**REPLY TO REQUEST FOR ADDITIONAL INFORMATION
INET SPIDER II MODEM
FCC ID MIVWG9701A**

August 19, 1998

This document has been compiled to reply to a series of questions posed by the FCC as part of the Equipment Authorization Process for the Inet Spider II Modem (FCC ID MIVWG9701A). Each of the questions listed by the FCC is listed prior to the reply.

**OCCUPIED BANDWIDTH DATA SHEET
INET SPIDER II WIRELESS MODEM**

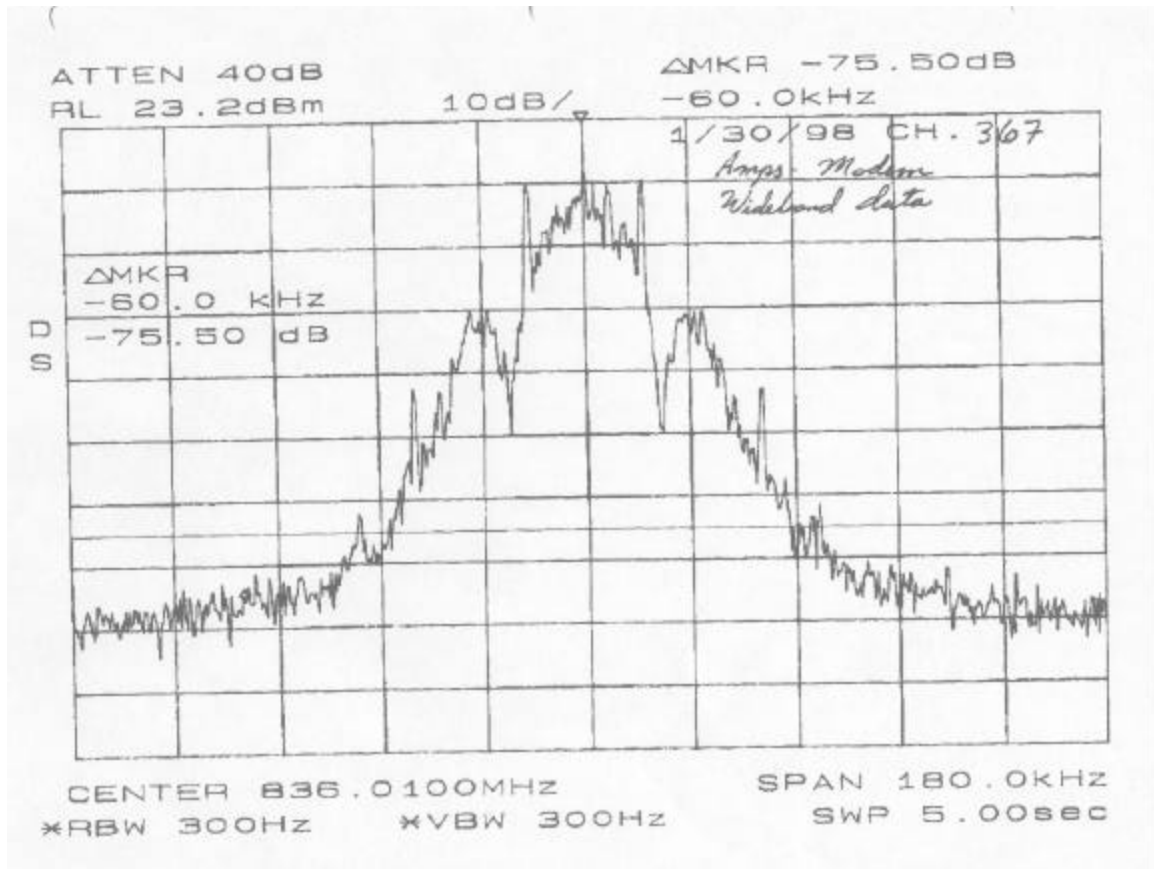
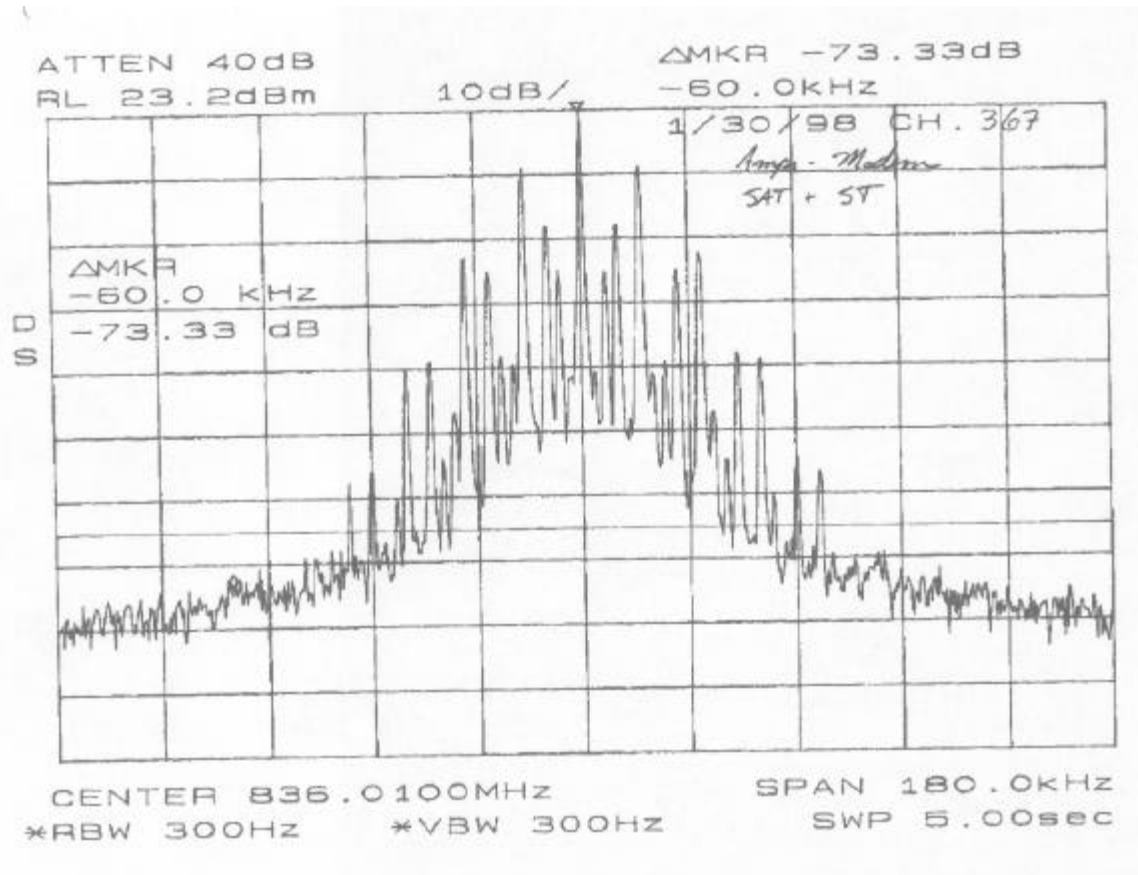
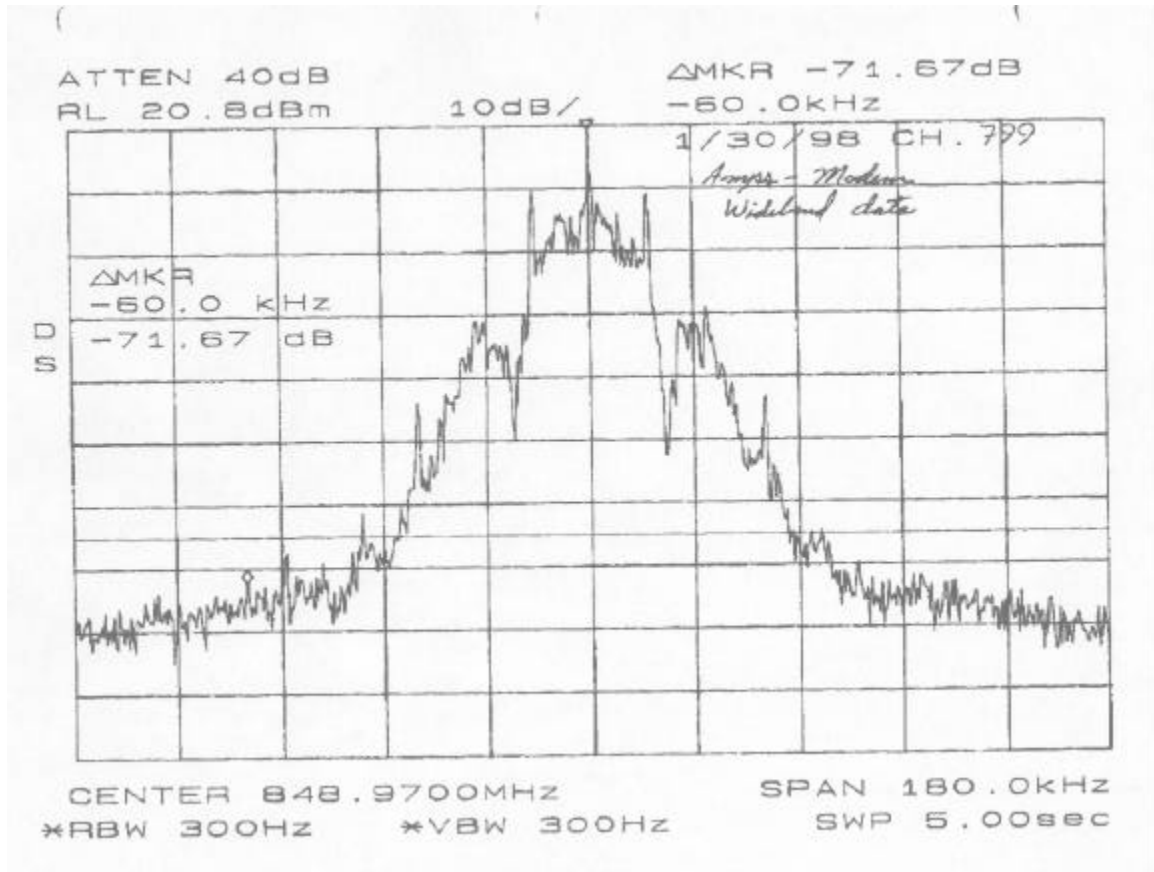
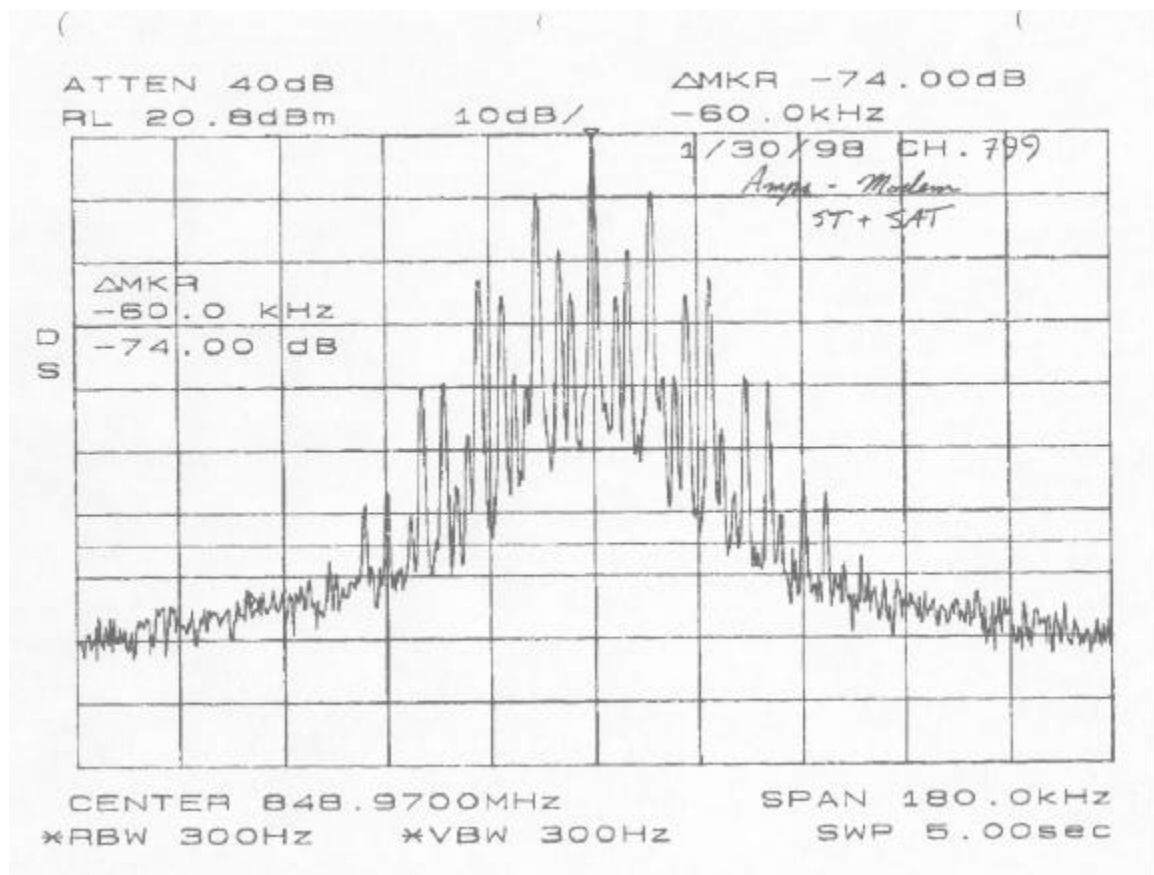
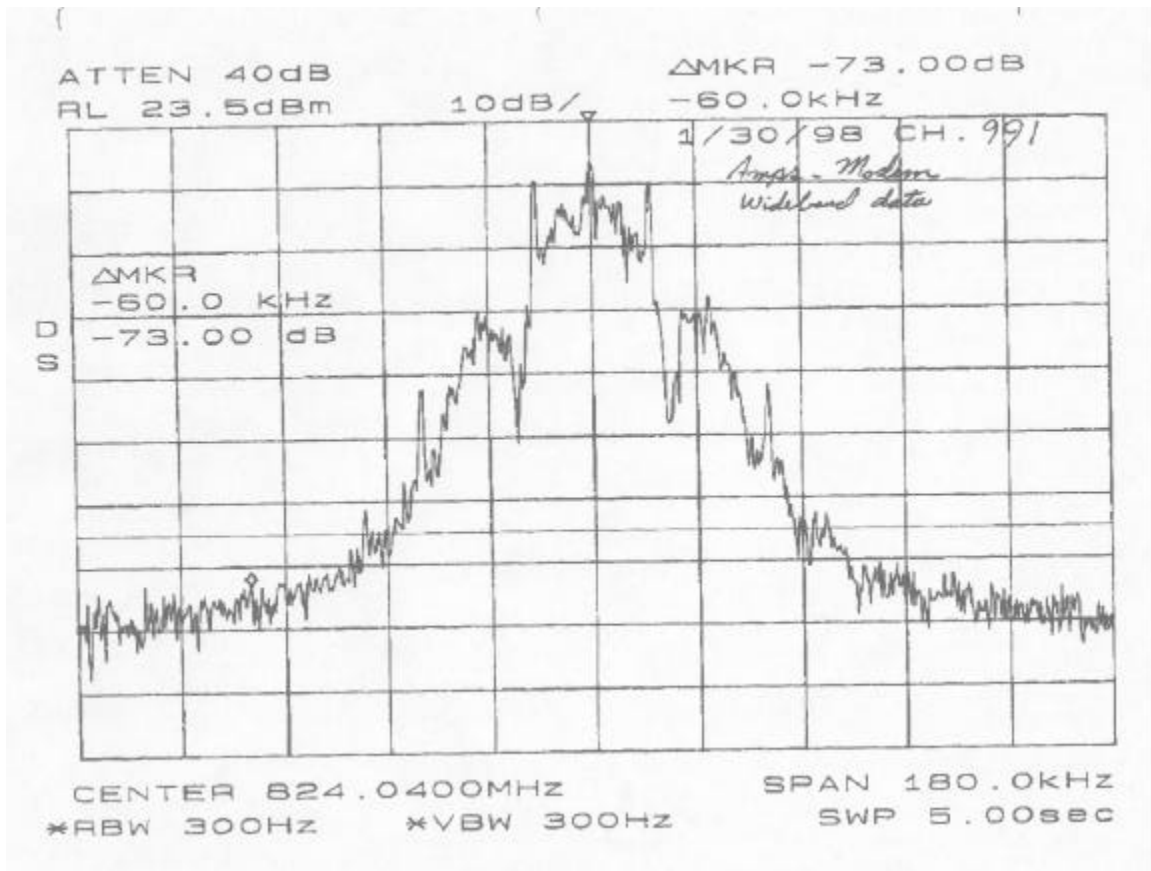
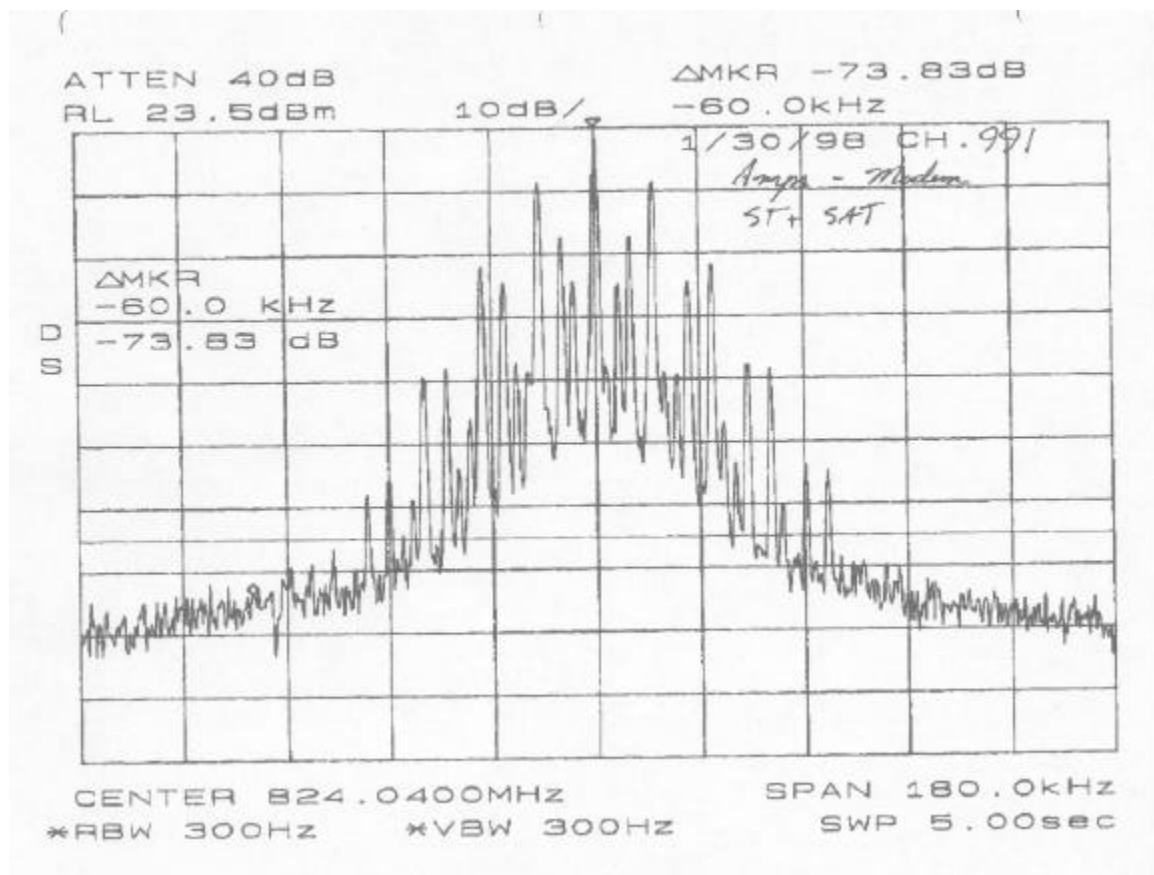
4) Please send an occupied bandwidth plot for operation in the wideband data mode.

Data for the wideband data operation in AMPS mode is included with this reply. Data is also present for operation in wideband mode for signalling tone plus SAT . Data is presented for three channels across the band.
